**FEDERAL RECALL CAMPAIGN 07KW9
C500'S MANUFACTURED APRIL 4, 2006 THROUGH MARCH 29, 2007 WITH SHEET METAL HOODS AND
STANDARD AXLE SETTING**

SITUATION

Figure 1; Hood support & brake chamber "before" repairs

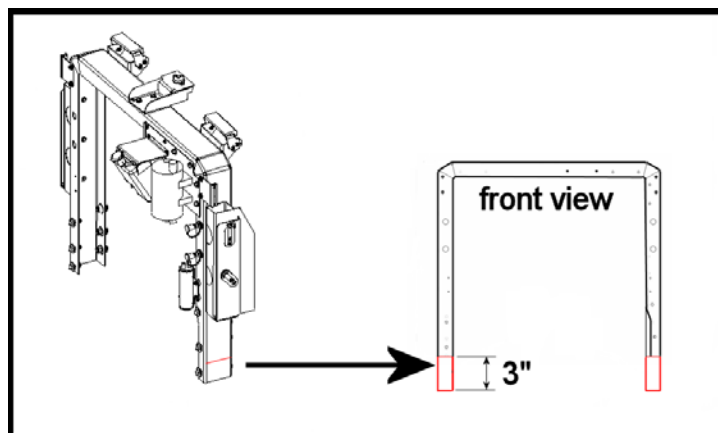
Hood support can contact brake chamber (see Figure 1).

Figure 2; Trim 3" from both legs of the over bell hood support

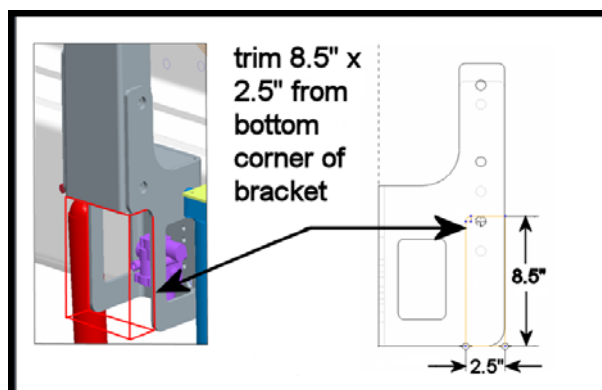
The repair includes trimming 3" from both legs of the over bell hood support (Figure 2), and trimming both the lower rear hood support on the passenger's side (Figure 3) and driver's side (Figure 4).

- Secure the hood before beginning repairs.
- Trim brackets using torch, grinder wheel or other cutting tool(s).
 - Protect/cover airlines while cutting.
 - Smooth the cut edges. Remove nicks and burrs.
- Prime and paint finished cuts (see Figure 5).
